Written Representations
Landscape and Visual Issues

In respect of DCO Application
Wylfa Newydd
Nuclear Power Station
by Horizon Nuclear Power

On behalf of
National Trust Wales

PINS ref
EN010007

Figure B1-2 Guide to significance scale

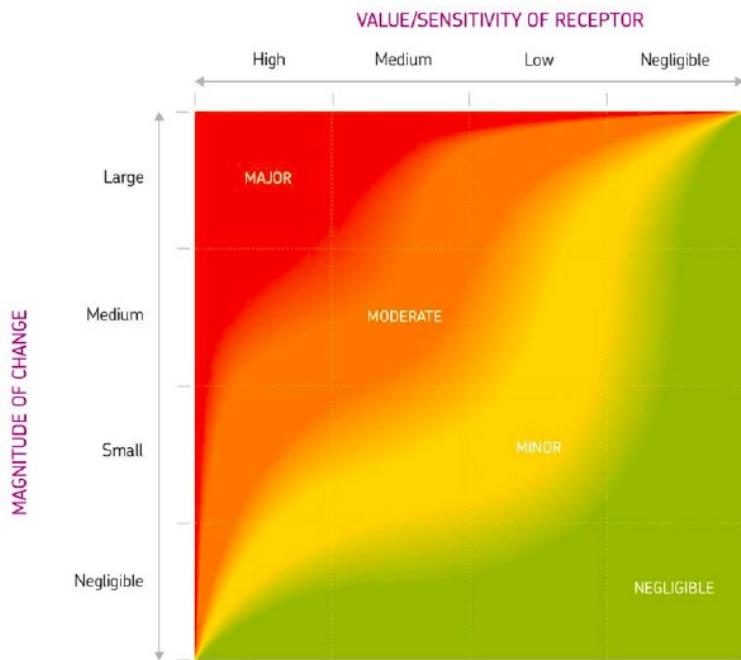
6.1.3 Chapter B1 only names four categories of effect, major, moderate, minor and negligible but the shading of the Figure implies that there are also intermediate categories, such as moderate/major. It is common practice for ES assessment to use such intermediate categories in order to differentiate between impacts. The application in the ES LVA of just four categories (major, moderate, minor and negligible) has resulted in a coarse-grained final assessment with regard to landscape and visual effects³⁰, where the sensitivity of the receptor, particularly for high sensitivity receptors, appears to have very little effect on the conclusions with regard to effects. This is explained in detail below.

6.1.4 The ES LVA has concluded that for a large number of visual receptors the magnitude of change would be medium. It is common practice that where there is a medium magnitude of change for a high sensitivity receptor the significance of the effect is moderate/major. Where there is a medium magnitude of change for a medium sensitivity receptor the

6.1.5 Landscape receptors with high sensitivity include the Anglesey AONB, the North Anglesey Heritage Coast and several local landscape and seascape character areas. For all of these highly sensitive receptors where the magnitude of change is considered to be medium the significance of the effect has been judged to be moderate. Based on Figure B1-2 if no intermediate categories are being used it is likely that at least half the time a medium magnitude of change for high sensitivity receptor would result in a major effect.

6.1.6 With regard to visual effects that are two instances where the ES LVIA concludes that a medium magnitude of change for a high sensitivity receptor results in a major adverse effect³¹ but for all the remaining receptors the conclusion is that there would only be a moderate effect. For all landscape and visual receptors considered to have medium sensitivity that would be subject to a medium magnitude of change the ES LVIA concludes that the effect is moderate. The result is a very large number of 'moderate effects' that does not differentiate between high and medium sensitive receptors and does not properly reflect the sensitivity of highly sensitive landscape and visual receptors.

6.1.7 There is a similar downplaying of effects where it is judged that there is a small magnitude of change. In 6.2.10 ES Volume B - B10 - Landscape and visual, on all occasions when there is a small magnitude of change, to either a high sensitivity receptor or a medium sensitivity receptor, the result is a minor effect and not significant. Based on Figure B1-2, for only a small percentage of occasions on which a high sensitivity receptor is subject to a small change should the resulting effect be minor.
